Subject: Submittal of Topical Report BAW-10199P, Addendum 1, "The BWU Critical Heat flux Correlations," December 2000.

SUBJECT: ACCEPTANCE FOR REFERENCING OF LICENSING TOPICAL REPORT
BAW-10199P, ADDENDUM 1, "THE BWU CRITICAL HEAT FLUX
CORRELATIONS" (TAC NO. M96728)

TOPICAL REPORT BAW-10199P, ADDENDUM 1

**BAW-10199P-A, The BWU Critical Heat Flux Equations,
Addendum 1:**

Figure Q-1.1

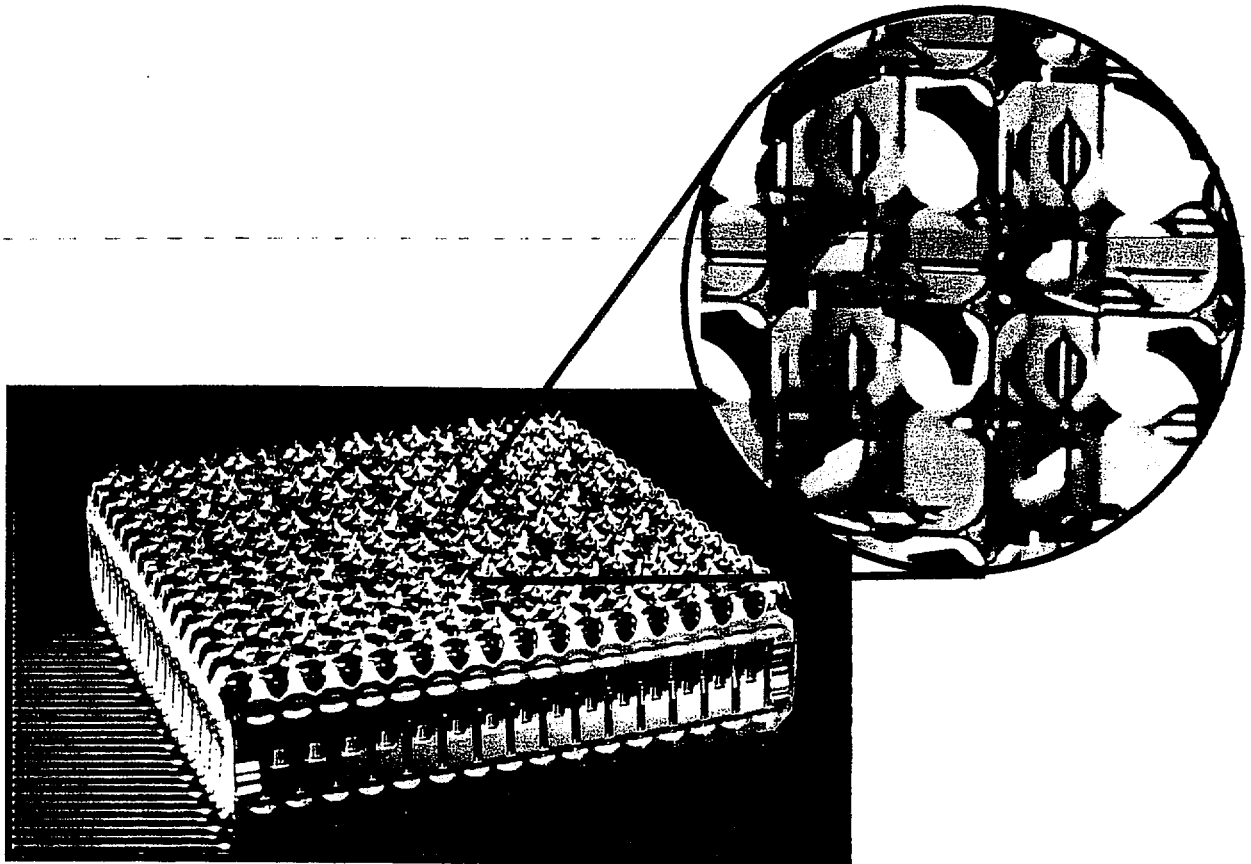
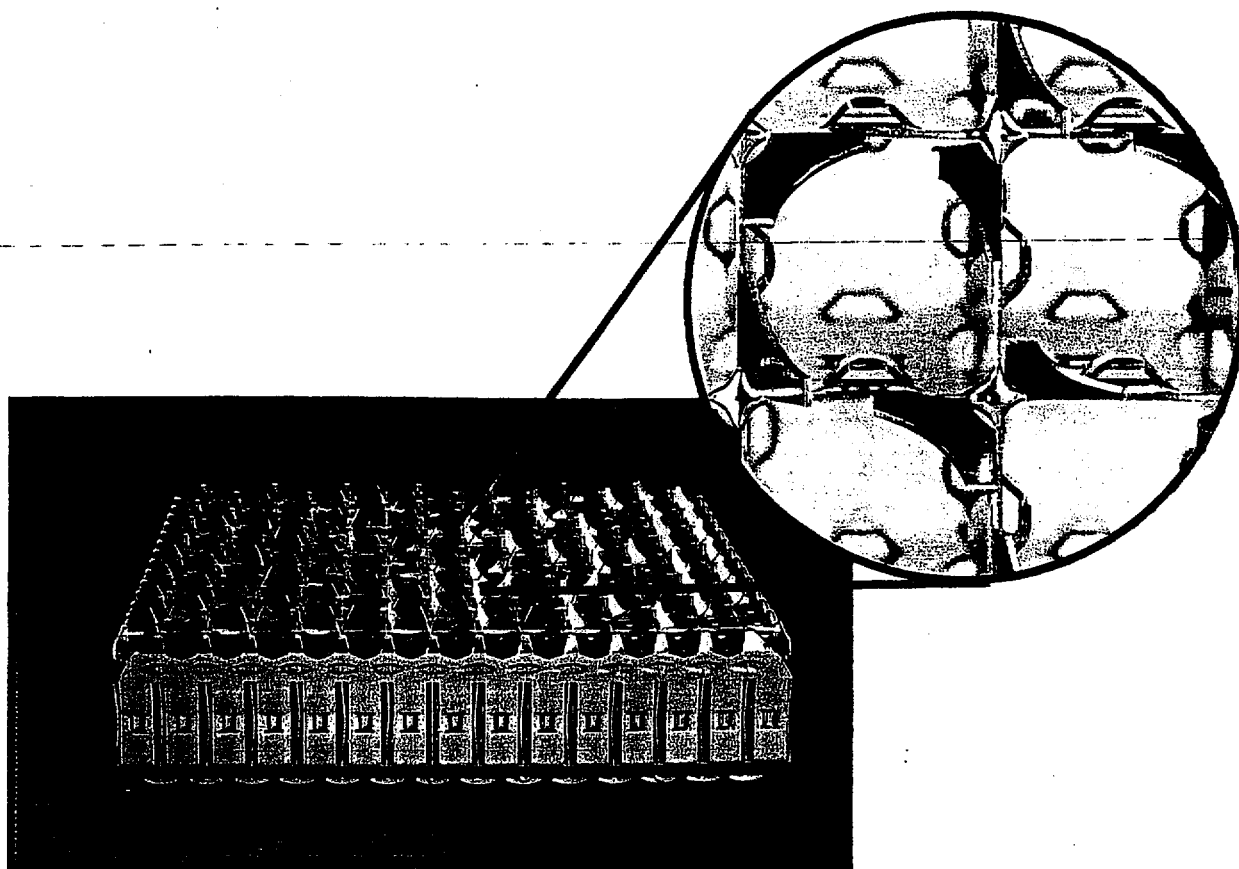
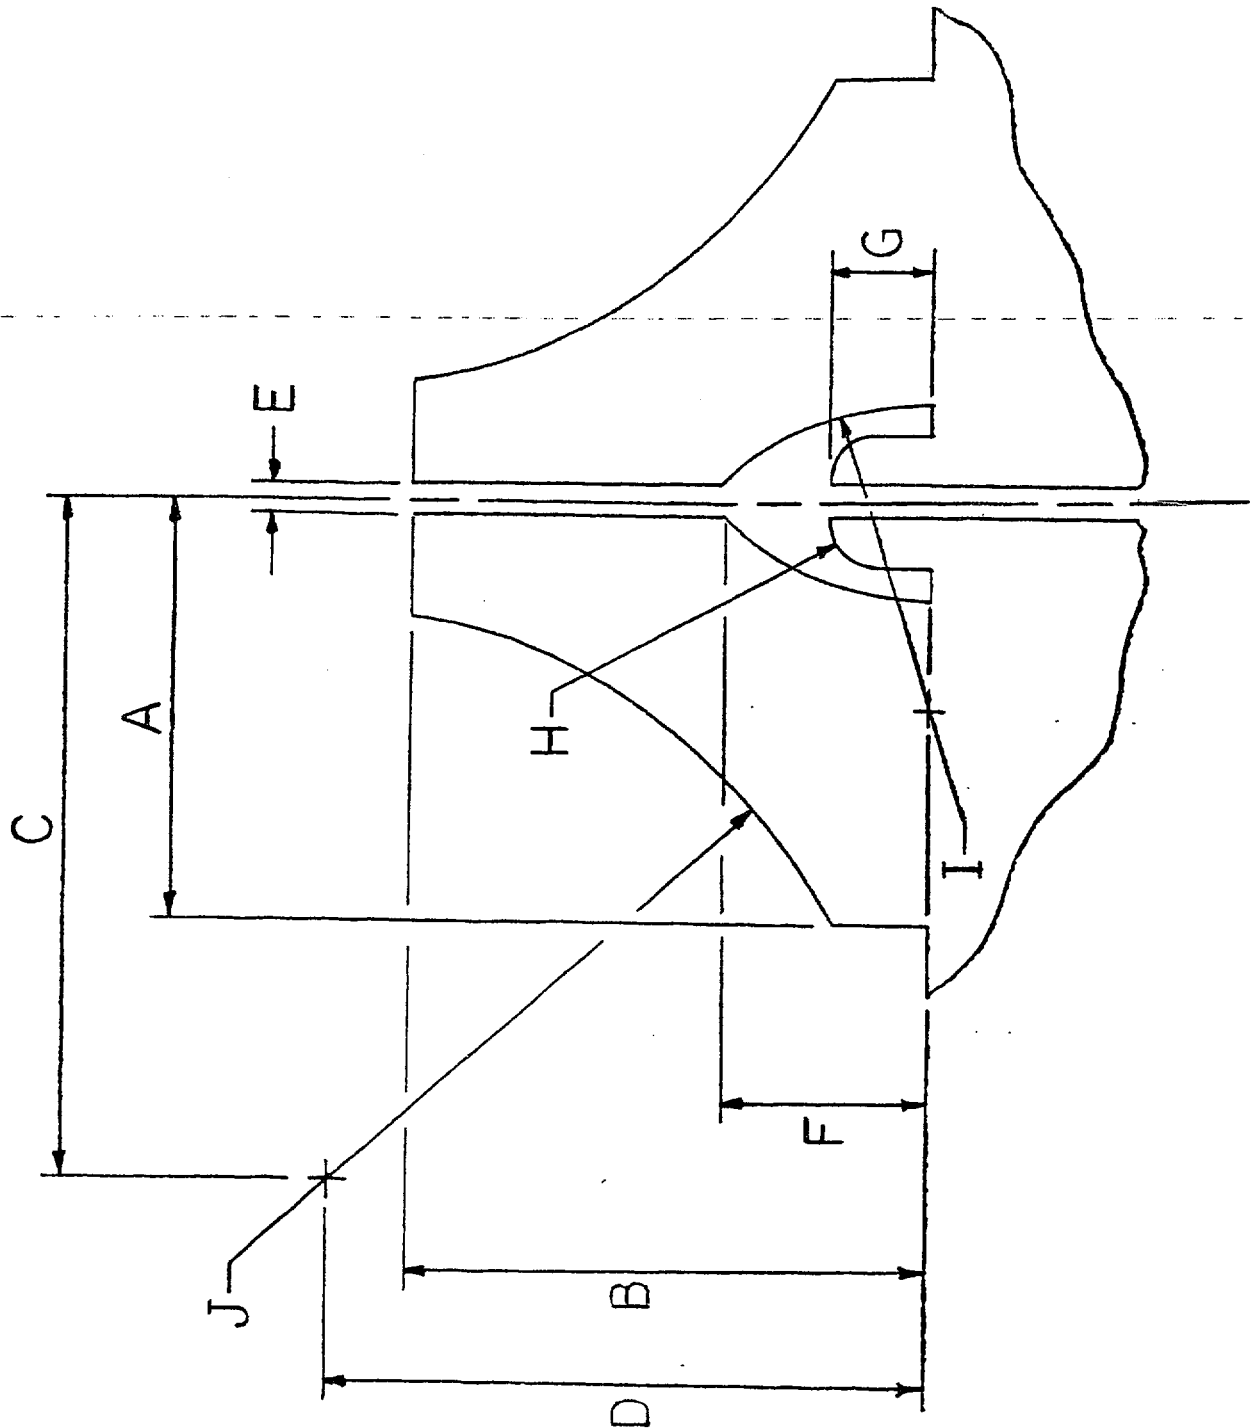
QUESTION 1

The Mark BW17 spacer grid is comprised of a square array of zircaloy strips used to maintain the correct cross sectional geometry for the fuel rod array of the Mark BW17 fuel assembly. The 0.374 inch diameter fuel rods are arranged in the 17-by-17 array with a pitch of 0.496 inches. At the intersection of each strip, there are two mixing vanes bent at an angle nominally { }^c degrees from the vertical and encircling about one quarter of each adjacent fuel rod. The purpose of these mixing vanes is to enhance the thermal-hydraulic performance of the Mark BW17 fuel assembly by intermixing coolant from adjacent channels, increasing the general turbulence level, and precluding or delaying the formation of a steam film on the surface of the fuel rod. Mark BW17 spacer grids are 2.25 inches in height and are spaced axially along the fuel assembly at 20.5 inch intervals. Based on Reference 1, the BWU-Z CHF correlation was approved to describe the thermal-hydraulic (CHF) performance of the Mark BW17 spacer grid.

The most important factor in the determination of the thermal hydraulic performance of a mixing vane spacer grid is the mixing vane. The following table is a detailed comparison of the Mark BW17, the Mark BW17 MSM and the Mark B11 vane designs. The dimensions are in inches and are referenced to Figure Q-1.3. Note that the ratio for dimensions A through D of { }^{c,d,e} is the ratio of the Mark B11 pitch (0.568") to that of the Mark BW17 (0.496"). Dimensions E through I describe the weld nugget cutout and weld tab and thus are the same for each design (with a ratio of { }^{c,d,e}). Finally, the ratio for the dimension J radius is slightly lower than the pitch ratios to preserve the vane to rod clearance.

In summary, from a thermal-hydraulic (CHF) enhancement standpoint, all three grids are conceptually and functionally identical. The levels of thermal-hydraulic performance are virtually identical as detailed in the addendum and in the response to question 3. The multiplier for the Mark B11 { }^{c,d,e} is within accepted CHF uncertainty. The multiplier for the Mark BW17 MSM { }^{c,d,e} is a conservative enhancement based on the configuration (mid-span placement).

Figure Q1a-1
Mark B11 Replicate Data Base with $F_{B11} = 0.98$

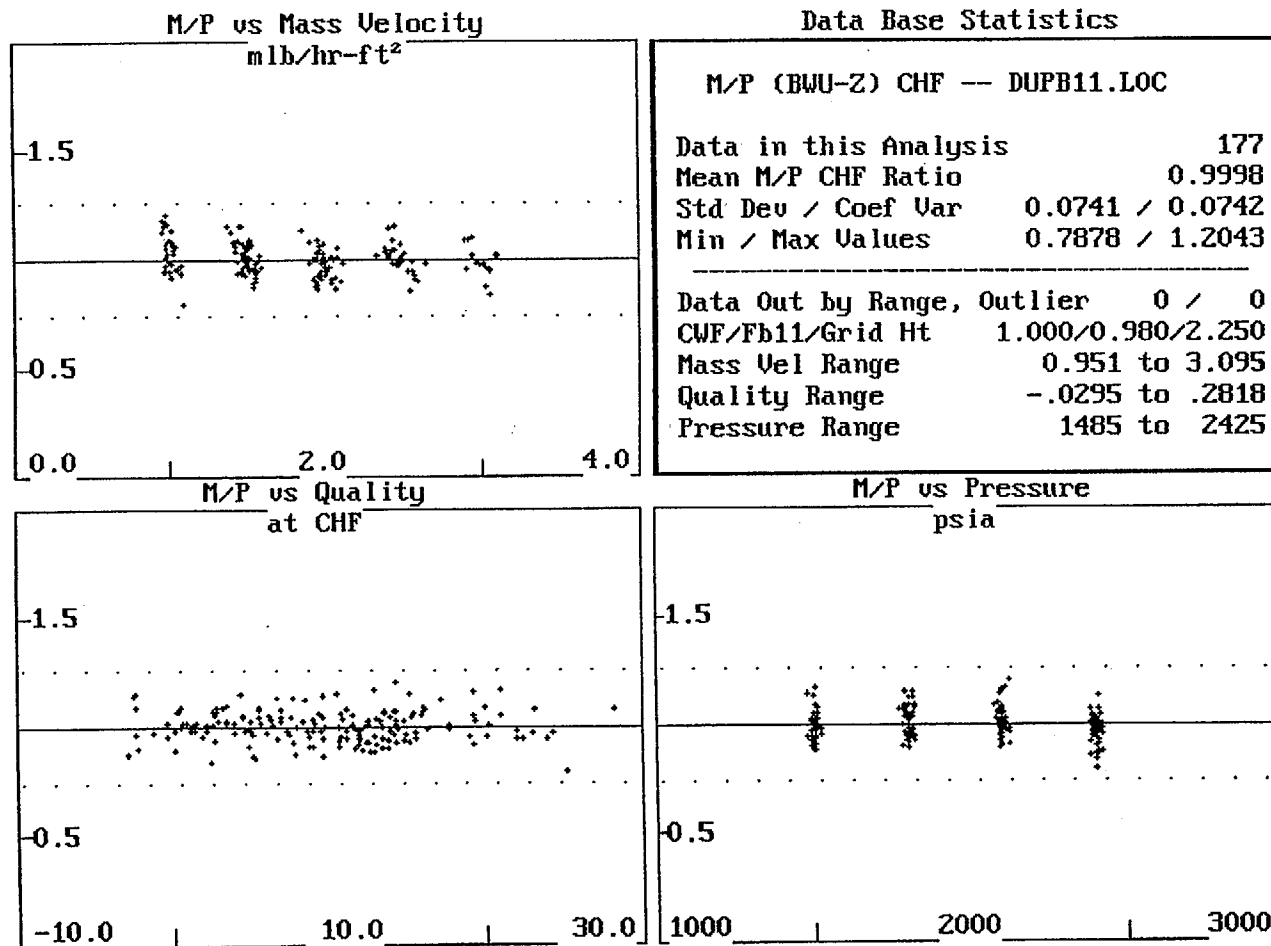
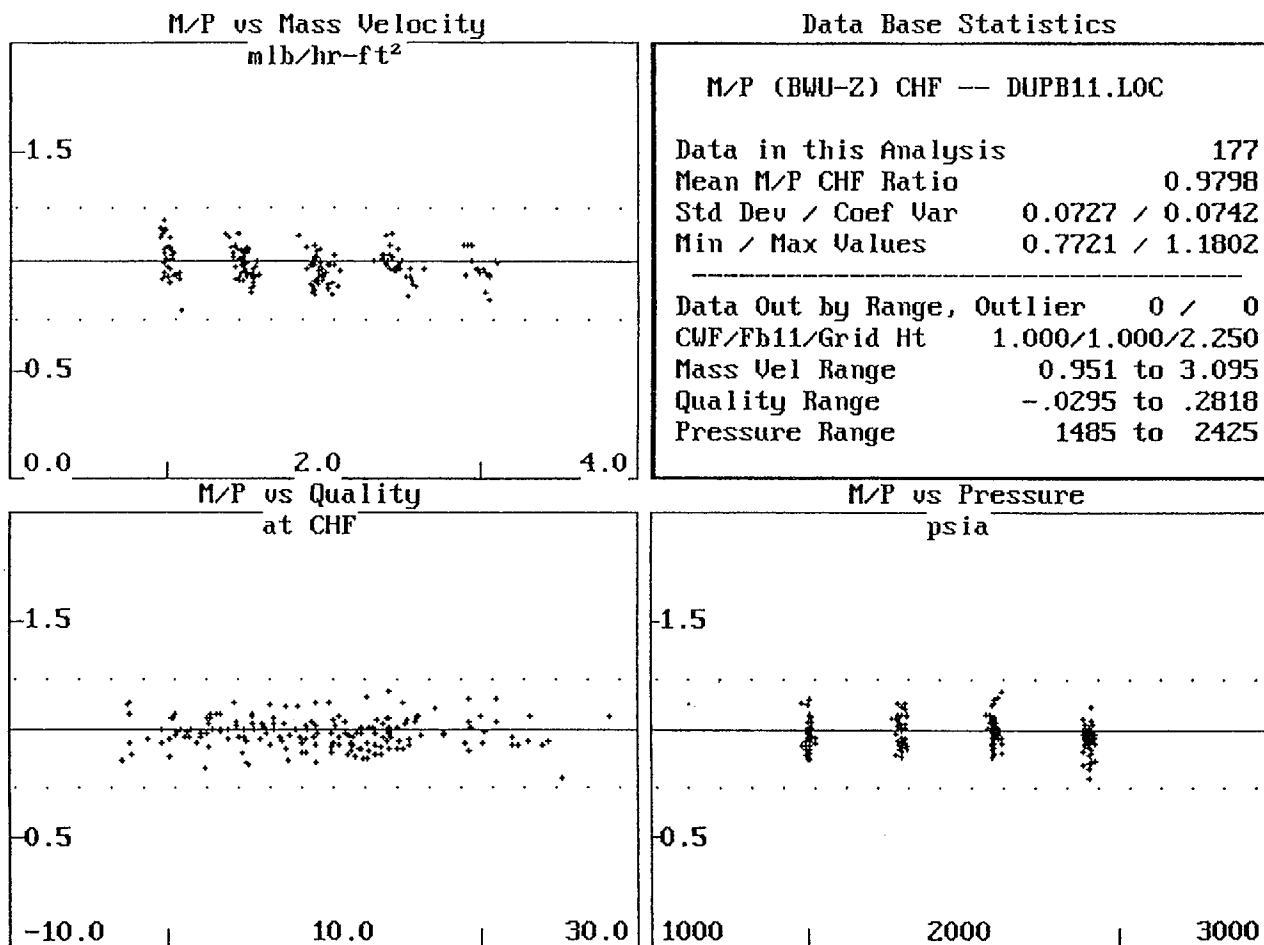
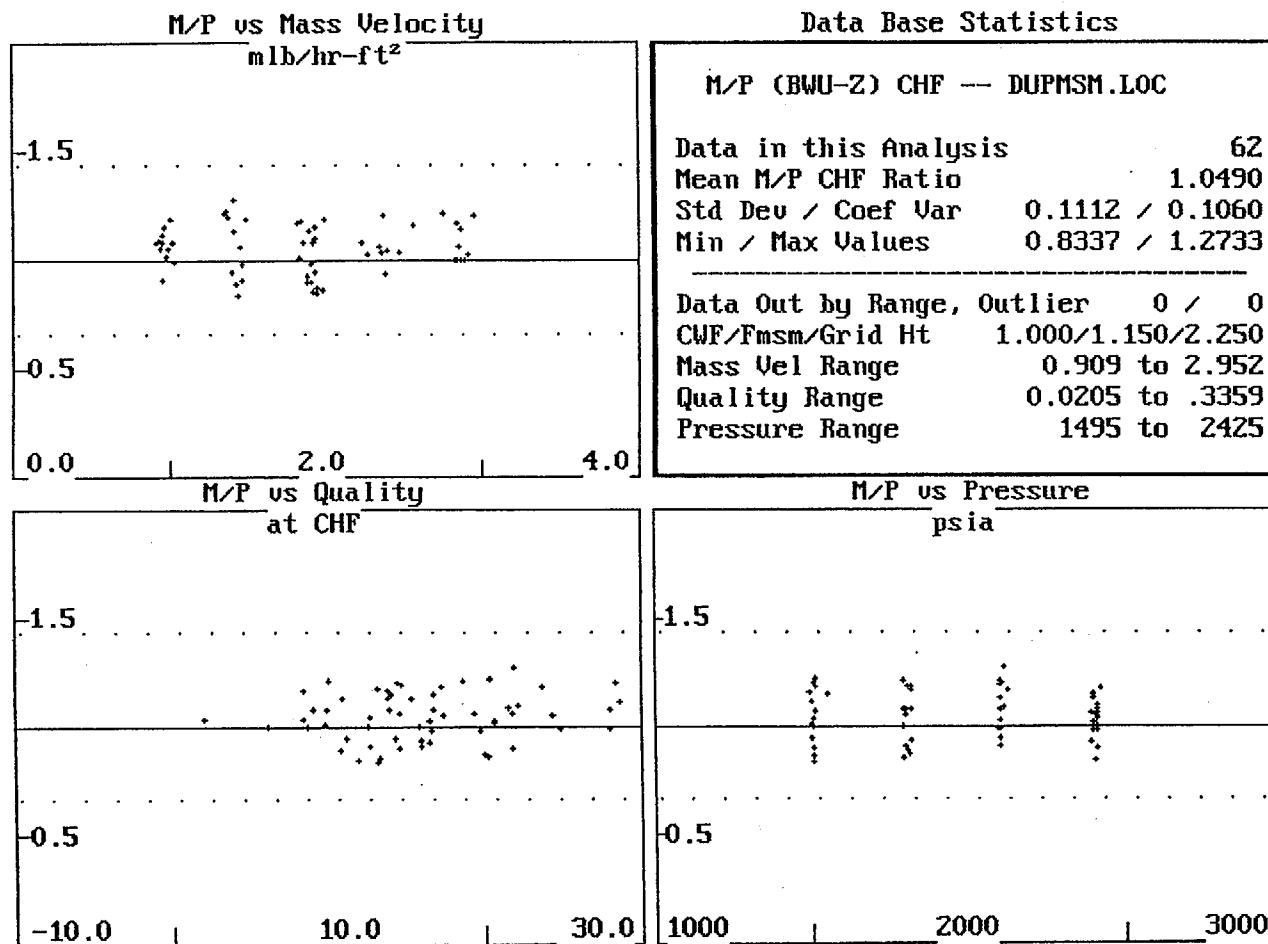
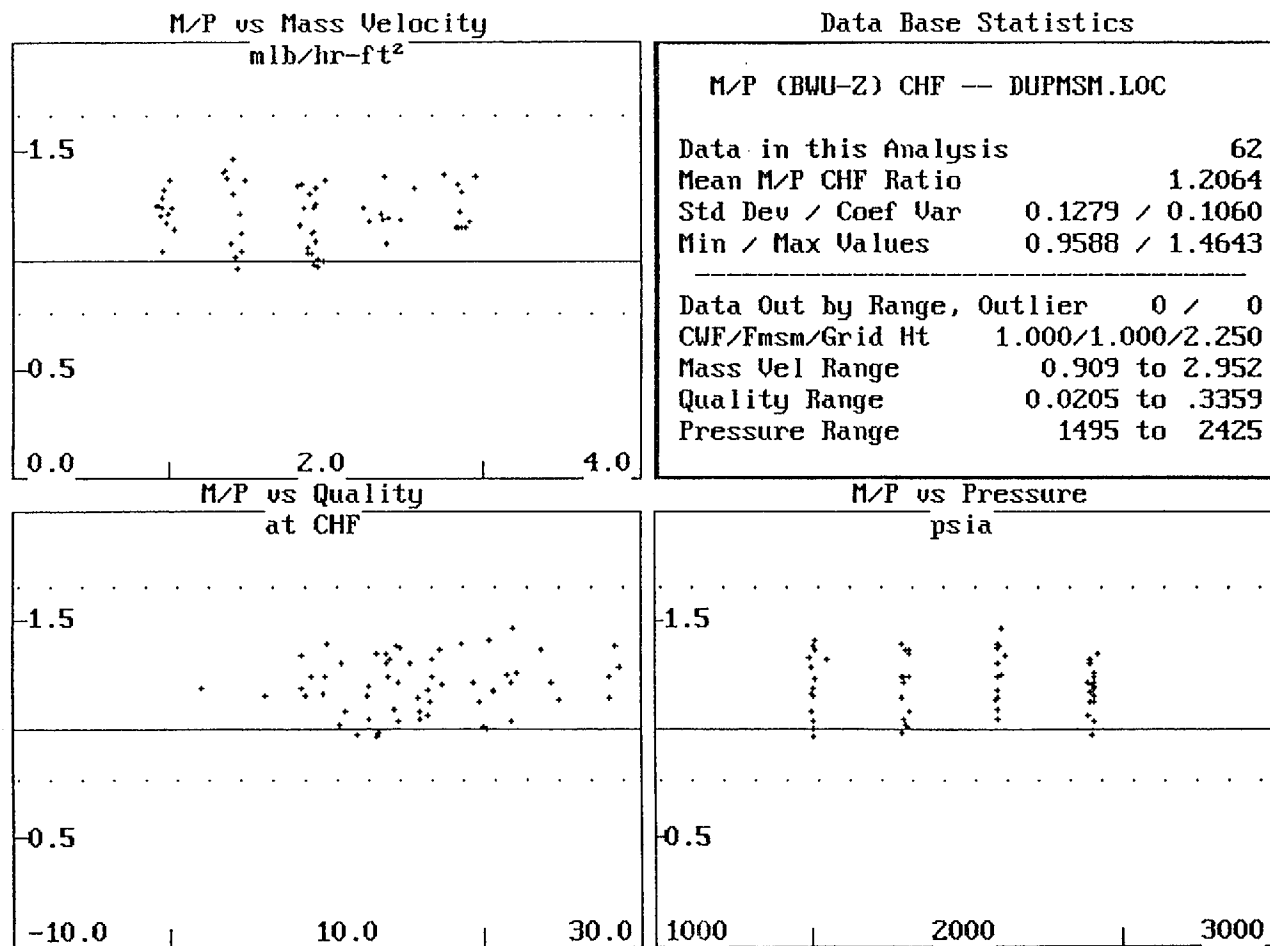
1. *The response to Question 3 dated February 23, 1998, states that no bias was found when the B11 and BW17-MSM data bases were analyzed with the BWU-Z correlation, and only the "average levels" were different. Please provide information supporting this conclusion, in the form of*

Figures Q1a-1 and Q1a-2 show summary bias plots of the Mark B11 replicate data set with $F_{B11} = 0.98$ and 1.0 respectively. Figures Q1a-3 and Q1a-4 show these summary bias plots for the Mark BW17-MSM replicate data set with $F_{MSM} = 1.15$ and 1.0 respectively. Finally, for reference, Figure Q1a-5 shows the summary bias plots for the replicate Mark BW17 data base of 411 data. It should be noted that the change in $F_{B11} = 0.98$ to 1.0 merely raises each M/P value on the summary bias plots by 2 percent uniformly (i.e., the predicted CHF, P in the M/P value, is multiplied by 0.98). Likewise the change in $F_{MSM} = 1.15$ to 1.0 lowers the values uniformly by 15 percent. F_{B11} and F_{MSM} are simple normalization factors. The corresponding normalization factor for the Mark BW17 data base is, of course, 1.0. Thus any bias with respect to the independent variables can be seen regardless of the F_{B11} or F_{MSM} values.
